SANYO 10X-856N

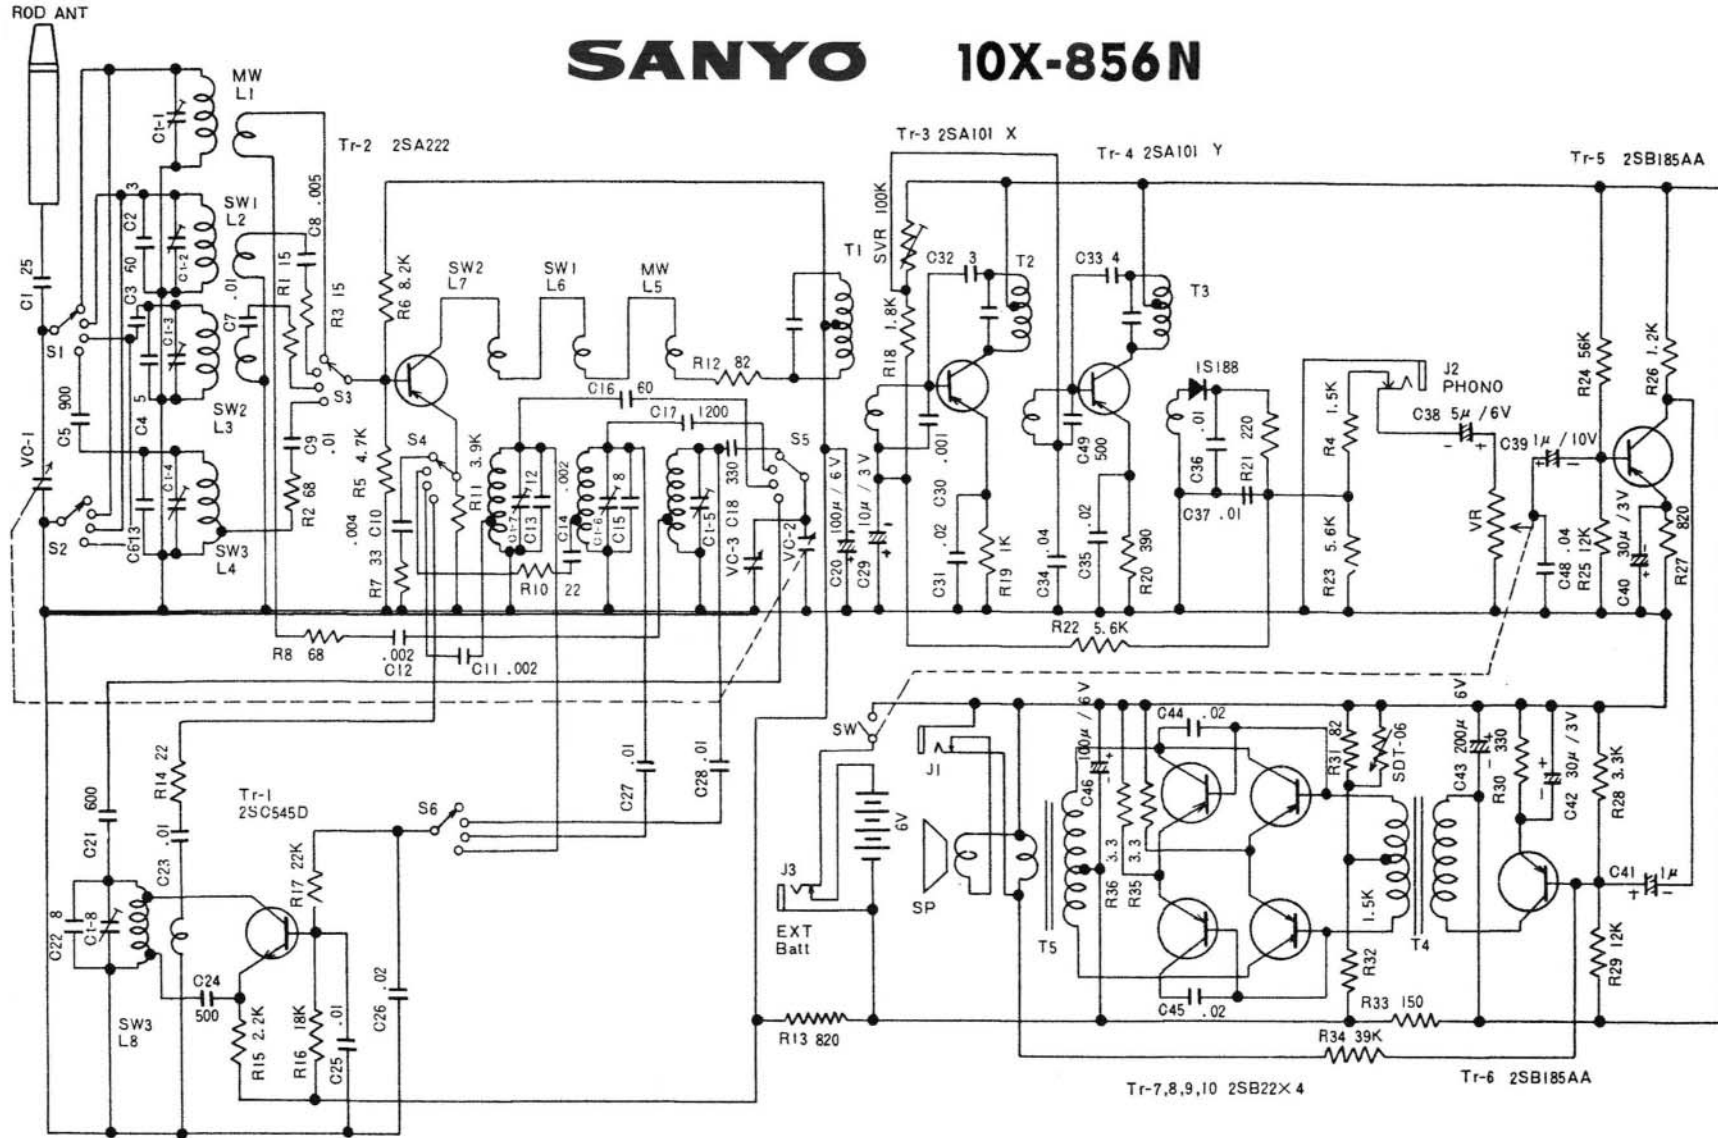
NOTE : Following modifications made from latest production
 C4 4pF → 7pF C15 8pF → 12pF
 C50 3pF newly incorporated in parallel with Ct5.
